PUBLIC HEARING/WORKING SESSION MEMORANDUM

PETITION #427-20

41 Washington Street

Petition #427-20, for SPECIAL PERMIT/SITE PLAN APPROVAL to allow a rear lot subdivision to create two lots, abandon the two-family use in the existing structure and construct a single-family on the rear 12,000 sq. ft. lot, extending the existing non-conforming side setback at **41 Washington Street**, Ward 1, Newton, on land known as Section 71 Block 29 Lot 07, containing approximately 25,902 sq. ft. of land in a district zoned SINGLE RESIDENCE 3. Ref: 7.3, 7.4, 3.1.5, 3.1.10, 3.1.3, 7.8.2.C.2 of Chapter 30 of the City of Newton Rev Zoning Ord, 2017.

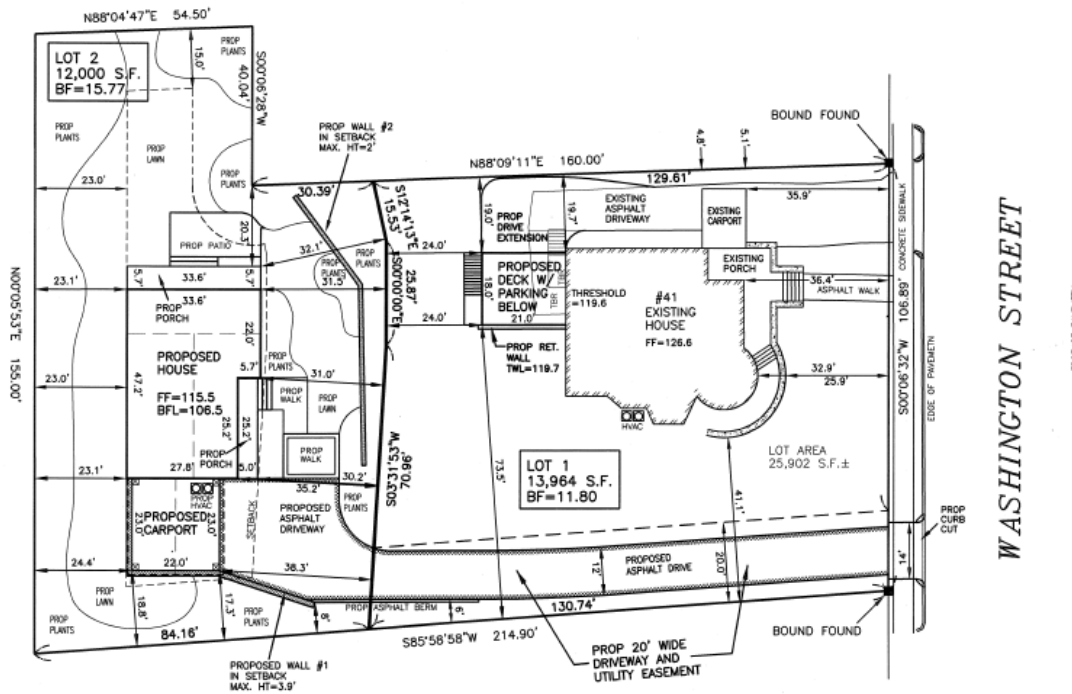
The Planning Department notes that at approximately 50 feet from two Grasmere Street homes, the rear dwelling’s carport would be the portion of the project would be the closest to abutting residential properties. Distances to the homes range, approximately, between 83 to 110 feet.

Also of importance regarding rear lot subdivisions is the relative height of rear lot dwellings and those on abutting parcels. As indicated on the area plan, the proposed rear dwelling’s height would be roughly the same or lower than those of abutting properties to the north, east and south and approximately 14-19 feet higher than two Merton Street-facing dwellings abutting directly to the west.
